2 Project

The application seeks approval for the redevelopment and operation of the Powerhouse Ultimo, comprising site preparation works, demolition of existing buildings and structures, alteration and adaptive reuse of heritage buildings, construction of new buildings, internal courtyards, public open spaces, and associated landscaping.

Figure 10 | View across Harris / William Henry Street intersection towards the existing (left) and proposed (centre) Wran Building arches and the proposed stratified brickwork pattern (right) (Base source: Applicant's RtS)

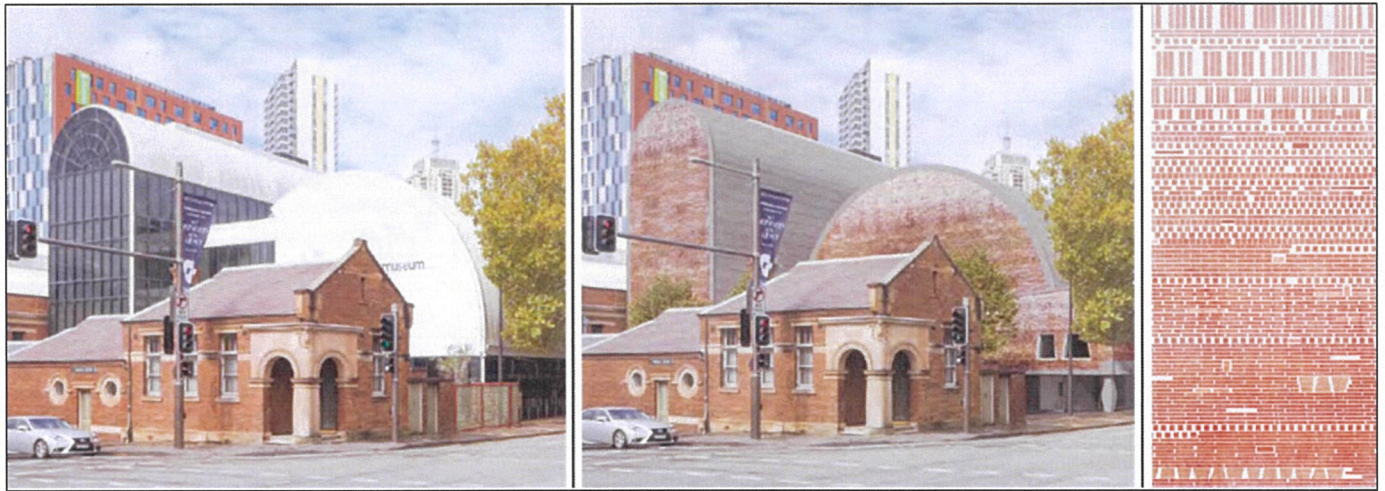
The HIS acknowledges that changes are proposed to the Wran Building. However, the HIS considers the changes would not have unacceptable heritage impacts, as (**Figure 10**):

- the SHR listing for the Wran Building highlights the distinctive arched roof form and scale as central to its heritage significance. The proposed design retains these key features, ensuring they remain prominent elements
- the fabric of the Wran Building has been heavily modified over time and the fabric for removal is not identified as being of heritage significance
- the proposed brickwork comprises a contemporary, stratified pattern (incorporating First Nations co-design) that contrasts with the brickwork of the Core Buildings and fUPO in a

Heritage NSW stated that the proposed use of brickwork and concrete, particularly on the north and south arched gables, transforms the character of the Wran Building and leads to the loss of the original intended contrast between the original heavy Core Buildings and the lighter-framed 1988 Wran Building. Heritage NSW noted that the Harris Street Wran Building facade enables framed views of the Switch House through discreet openings. Heritage NSW stated it would support improved visual permeability and activation of the Harris Street elevation. However, it accepted that enhancing views of the Core Buildings from the south and south-east would help mitigate the adverse impact of obstructing views to the Core Buildings from Harris Street.

Council requested that the Applicant justify the extent of the intervention in the Wran Building. It did not support the use of brick and concrete for the northern and southern gables and questioned the proposed brick's compatibility with the Core Buildings' heritage. Additionally, Council considered that heritage significance relates to the entire site as a connected group of buildings, and that the fabric of all buildings holds considerable significance.

The SDRP recommended refining the Wran Building's materials, including justifying the stratified brickwork and its link to Country, incorporating local and site-sourced materials, using sandstone, and enhancing the lighting and materiality of the Harris Street colonnade.

In response, the Applicant confirmed that the Wran Building's stratified brickwork has been refined to further distinguish it from the Core Buildings and to strengthen its connection to Country (**Figure 10**). In addition, the façade design and brickwork would continue to be developed during the design development stage, with a focus on reusing materials sourced from the site. To further manage overall heritage impacts, the Applicant has proposed to undertake photographic archival recording of all existing buildings and prepare a HIP for the site, as discussed at **Section 5.4**

The Department has carefully considered the proposed changes to the Wran Building, the concerns raised in submissions and the Applicant's response. The Department considers the proposed alteration, extension and adaptive reuse of the Wran Building is acceptable as:

- the proposal retains the distinctive roof form of the Wran Building, which is central to its heritage significance and positively impacts the maintenance of its aesthetic and technical significance

- the change in materiality from lightweight metal and glazing to brickwork, metal and concrete is sympathetic to the dominant materiality of the Core Buildings, fUPO and the broader precinct

- the stratified brickwork has been co-designed with Aboriginal stakeholders and has been further refined to ensure it complements, rather than competes with or detracts from, the 'exceptional' graded buildings on the site.
